**1 Products affected**

**3 Detailed description of change**

Product Change Notification					FEU improvement		
owner	creation date	release date	released by	change order no	rev	page	D10-003-795
dislercy	2016-05-02	2017-06-02	nowakfr	2010314	A	1 of 2

**2 Type of change**

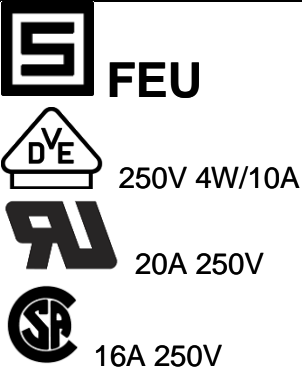
- Change of material
- Modified label
- Change of marking
- Improved voltage rating
- Improved electrical contact

The new materials fulfil the enhanced glow wire requirements according to the updated standard IEC 60127-6:2014 and are free of halogenated flame retardant and red phosphorus.
